UNITED STATES PATENT AND TRADEMARK OFFICE

APPLICATION NO.	FILING DATE	FIRST NAMED INVENTOR	ATTORNEY DOCKET NO.	CONFIRMATION NO.
10/686,857	10/16/2003	Andrew M. Hiles	HAM-100-A	1733

Office Action Summary

DETAILED ACTION

Exhibit A

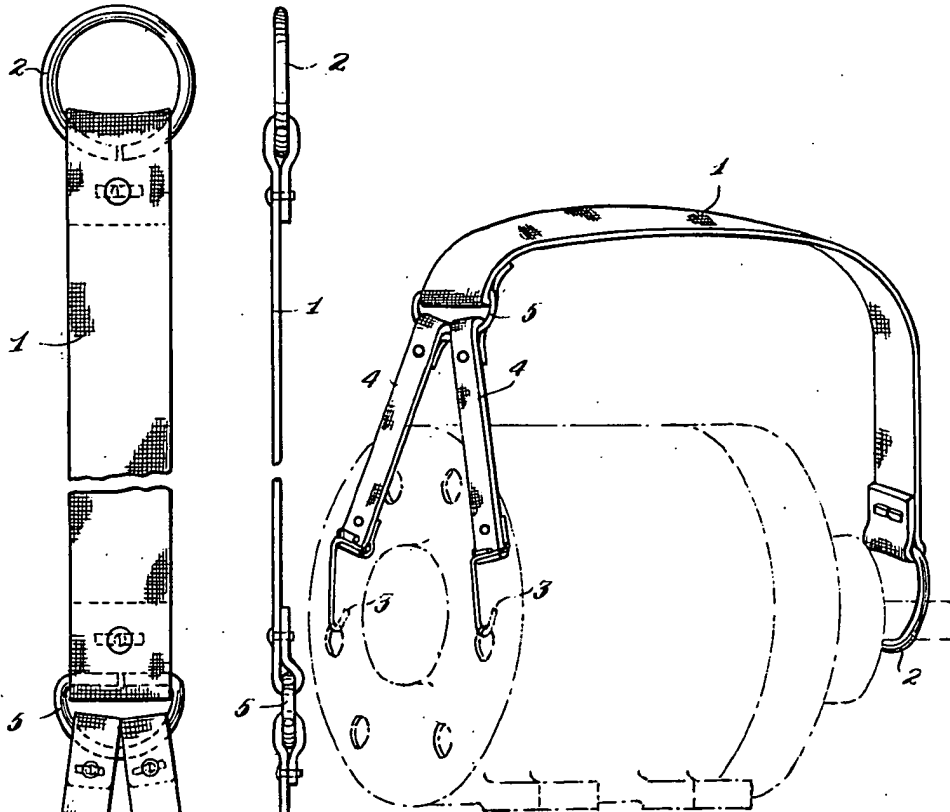
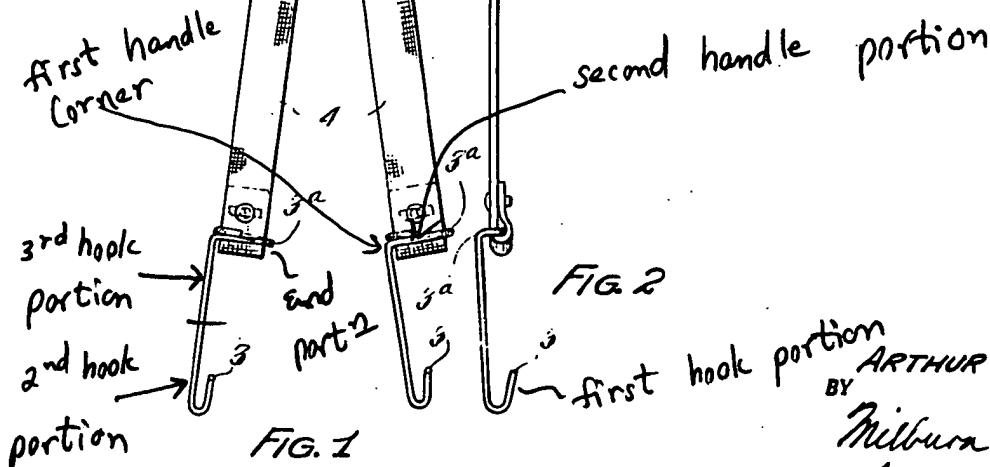
Vickers (2,541,449) discloses a lifting device comprising: a hook member (Figs. 1 and 2) configured in a predetermined shape having a substantially tapered end portion (see Fig. 2) and a second end portion; said hook member is provided with a predetermined opening between said tapered end portion and said second end portion; a fabric strap member (4) operably connectable to said hook member so that said strap member serves as a handle and an attachment to connect said hook member to an external pulling mechanism (2). It is pointed out that the prior art discloses all the structural limitations while the intended use (i.e. *for dragging a game animal and for gaffing a fish or marine animal*) is not patentably significant.

Re claims 3 and 4, Vickers (2,541,449) meets the limitations as broadly as recited in the claims (**see Exhibit A**).

Exhibit B

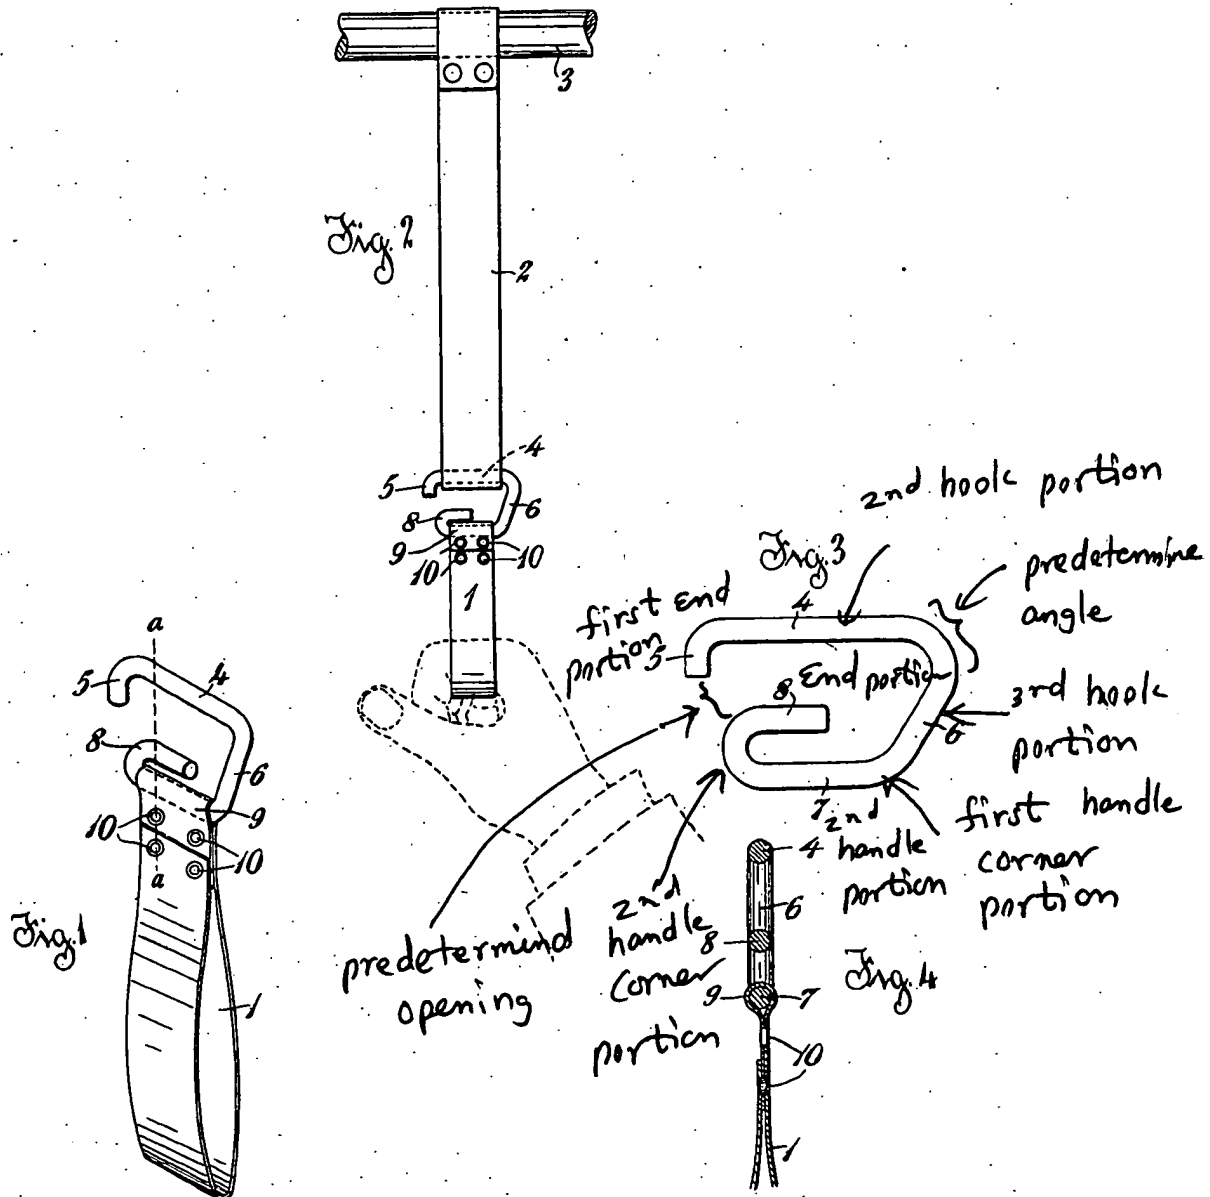
Autenrieth (937,564) discloses a lifting device comprising: a hook member (Figs. 1-3) configured in a predetermined shape having a first end portion (5) and a second end portion (8); said hook member is provided with a predetermined opening between said first end portion (5) and said second end portion (8); a strap webbing member (1,2) operably connectable to said hook member so that said strap member serves as a handle and an attachment to connect said hook member to an external pulling mechanism. Autenrieth (937,564) does not show a first end portion having a tapered end portion. However, Lutz (2,307,327) discloses a pointed member (12) having a tapered end portion (16) which has a tapered angle between 30 to 45 degree. Accordingly, it would have been obvious design choice to those skilled in the art to provide a tapered angle between 30 to 45 degree on the first end portion (5) of Autenrieth (937,564) as taught by Lutz (2,307,327) so that the end portion would be easily attached to the strap member (2). It is pointed out that the modified Autenrieth (937,564) discloses all the structural limitations while the intended use (i.e. *for dragging a game animal and for gaffing a fish or marine animal*) is not patentably significant. Re claims 3 and 4, the modified Autenrieth (937,564) discloses all the structural limitations (**see Exhibit B**). Re claims 13-20, the angle between the second hook portion and the third hook portion is a predetermined (see Exhibit B).
